### 3.4.2 POWER DISTRIBUTION LIMITS

#### AXIAL FLUX DIFFERENCE (AFD)

ATTACHMENT NO. 3 TO AEP:NRC:0710  
REVISED TECHNICAL SPECIFICATION PAGES FOR  
D. C. COOK UNIT NO. 2

Figure 3.2-3  $V(Z)$  As A Function of Core Height

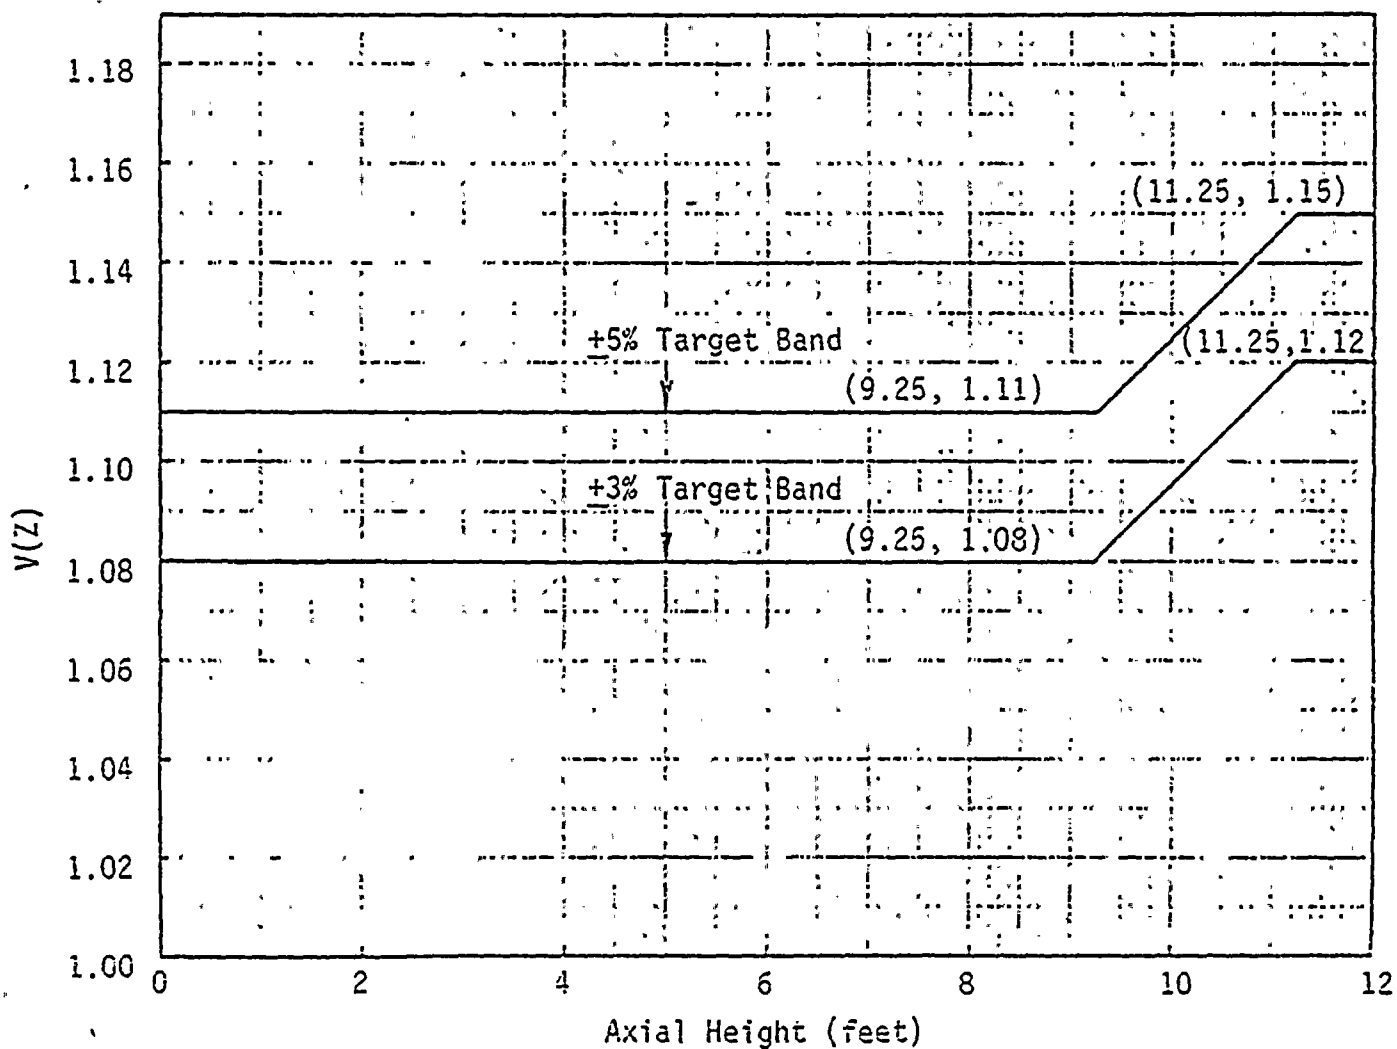
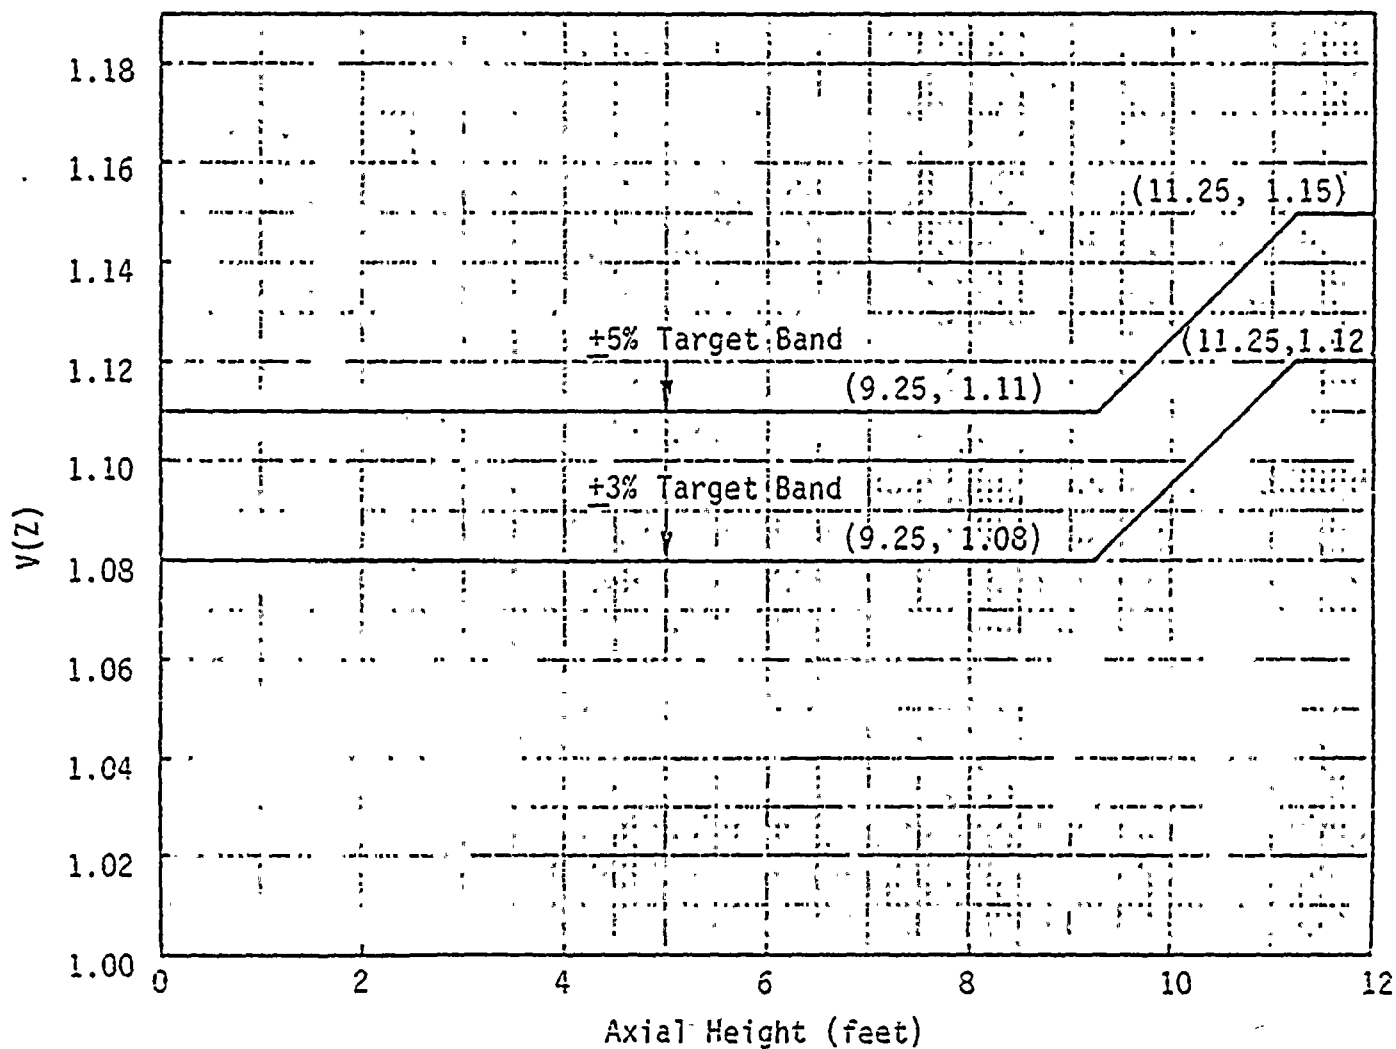
$V(Z)$  is the function defined in Figure 3.2-3 which corresponds to the target band,  $K(Z)$  is defined in Figure 3.2-2,  $P$  is the fraction of RATED THERMAL POWER.

where  $F_Q(Z)$  is the measured  $F_Q(Z)$ , including a 3% manufacturing tolerance uncertainty and a 5% measurement uncertainty, at the time of target flux determination from a power distribution map using the movable incore detectors.  $V(Z)$  is the function defined in Figure 3.2-3 which corresponds to the target band. The above limit is not applicable in the following core plane regions.
